Permit Type Permit Number Opened Date
Building/Residential/Misc/Porch B26000161 01/19/2026
Description of Work
SFD/ CONSTRUCT 20' X 12' OPEN DECK W/ STEPS AND 16' X 16' SCREENED PORCH W/ STEPS

13455 Allnutt Ln, Highland, MD 20777
 Design Conditions
 Design Code for Load Combinations
 Based on the 2021 International Residential Code

Amendment, Permit # B26000161

APPLICATION FOR WAIVER

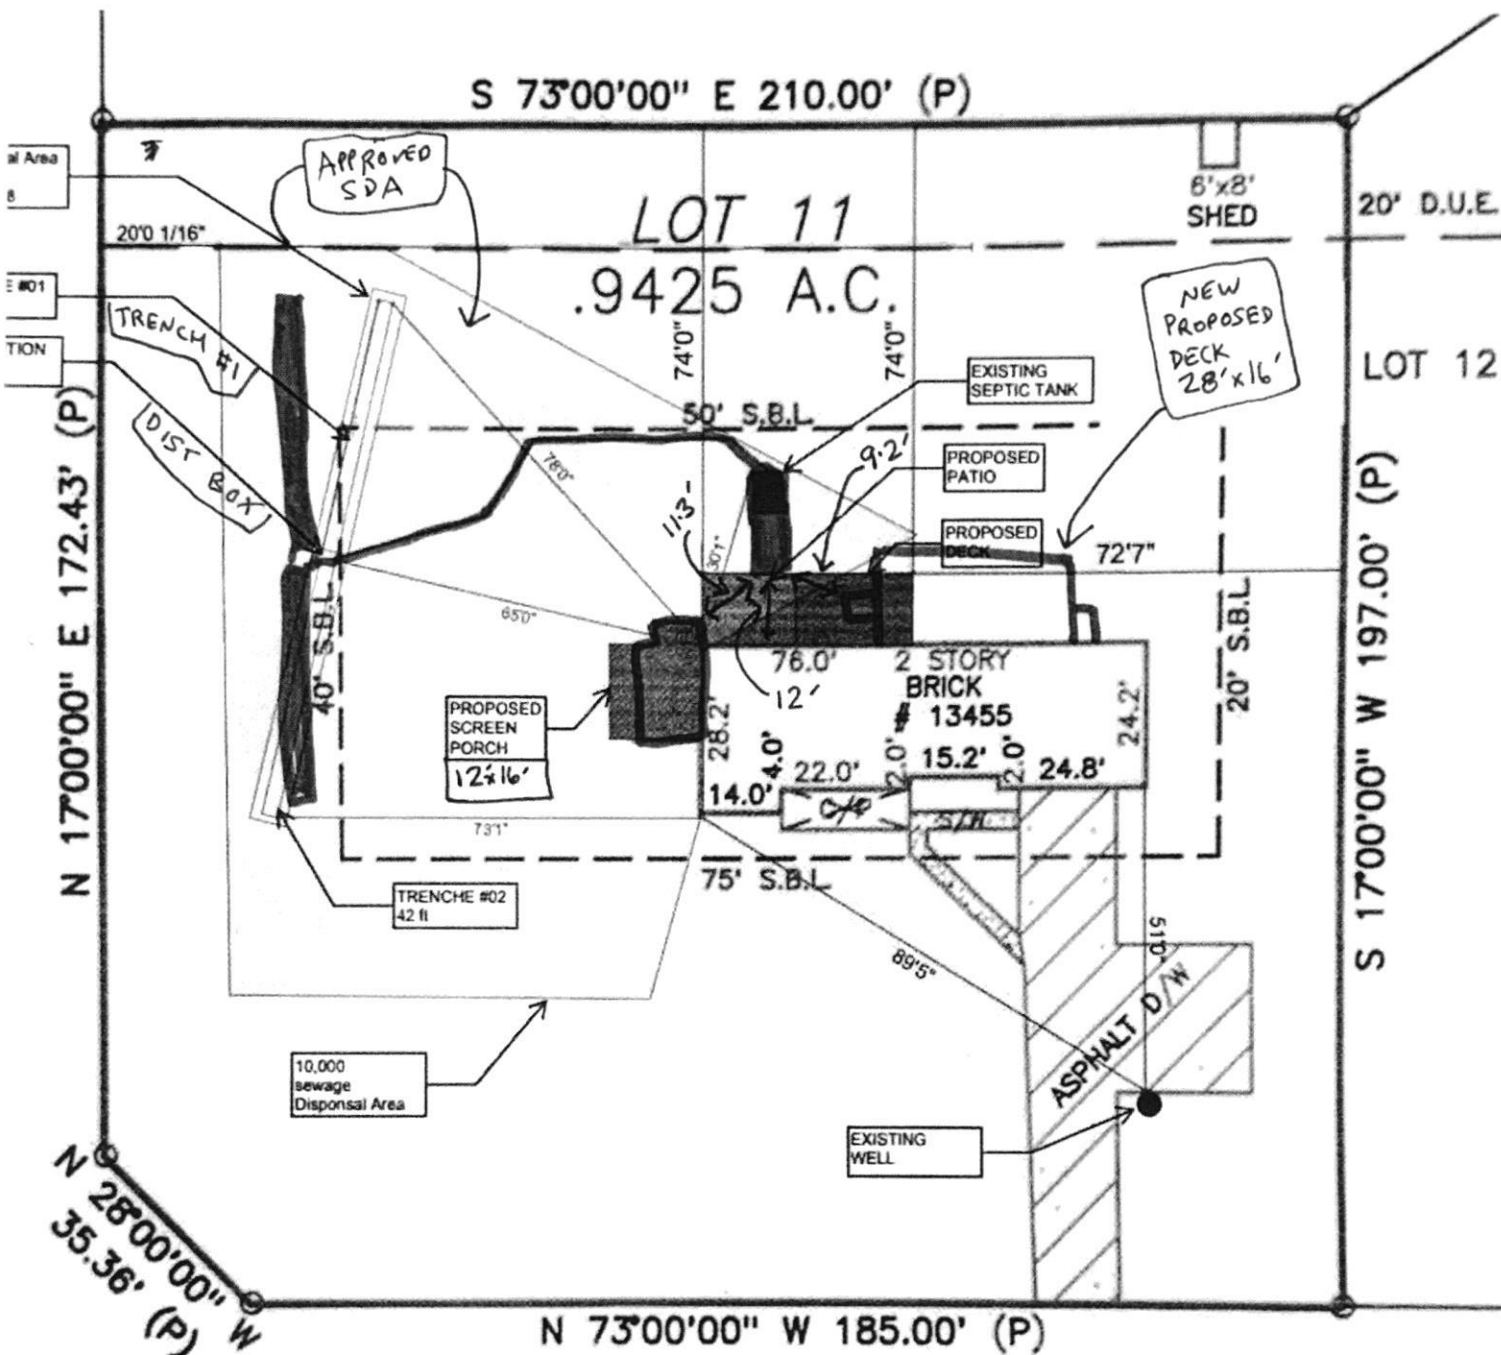
The screen porch measuring 12'x16' to be built on the east side of the house resides entirely within a sewage disposal area (SDA). The project is within the footprint of the original porch. The request is for a waiver for a percolation certification/PC plan and revised SDA requirement.

The deck measuring 28'x16' on the south side of the house resides partially within the SDA by about 2' and part of the deck resides completely in the 5' setback from the SDA. The project is within the footprint of the original deck. The request is for a waiver for a percolation certification/PC plan and revised SDA requirement.

approved as shown on attached plan - to not encroach into SDA beyond existing improvements. Any future future space addition or encroachment into SDA will require a revised perc cert

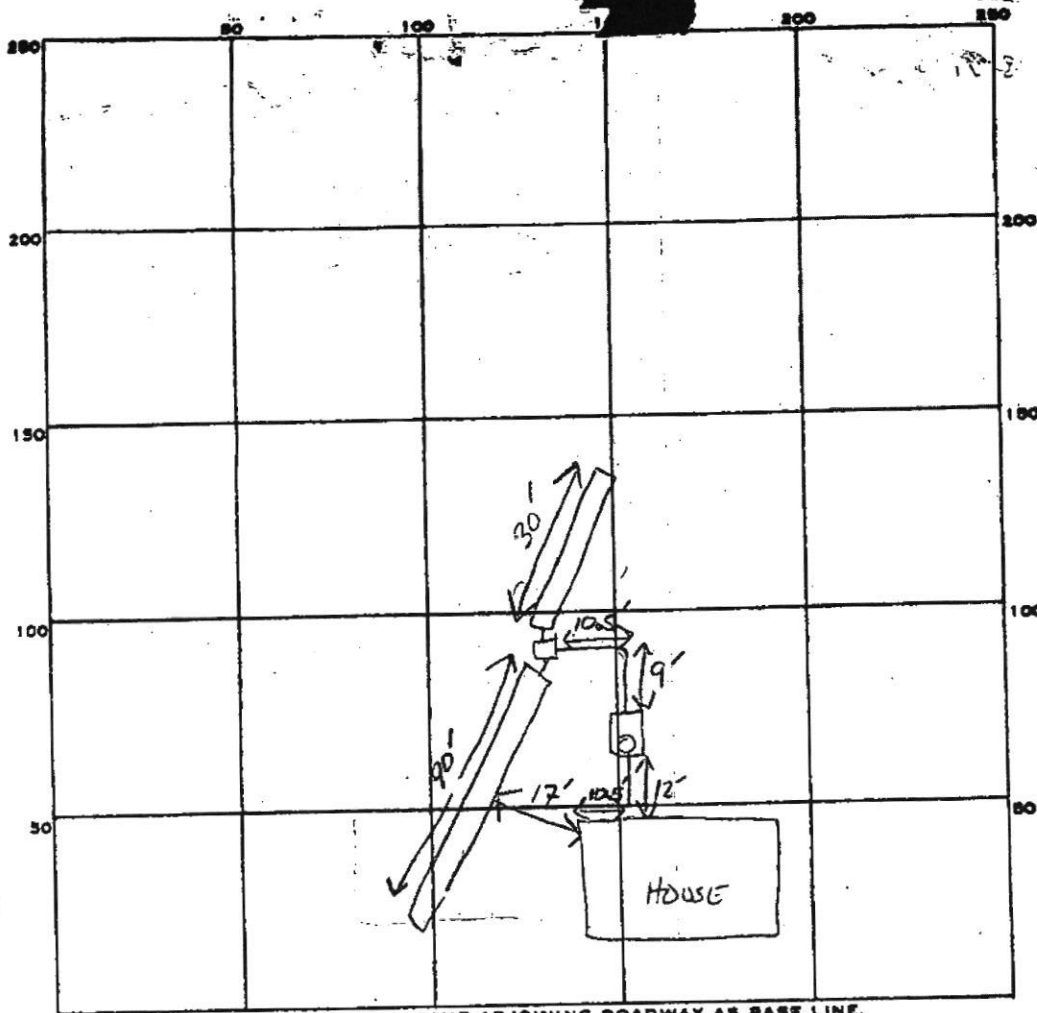
After review of the deck & screened porch proposal under B26000161, we kindly request that submit a revised site plan showing the well and septic components on the property to ensure that setback requirements are met. Please show the HD approved sewage disposal area (SDA), along with the septic tank and trenches (see attached record). If you should have any questions please do not hesitate to reach out. Thank you and have a great rest of your day.
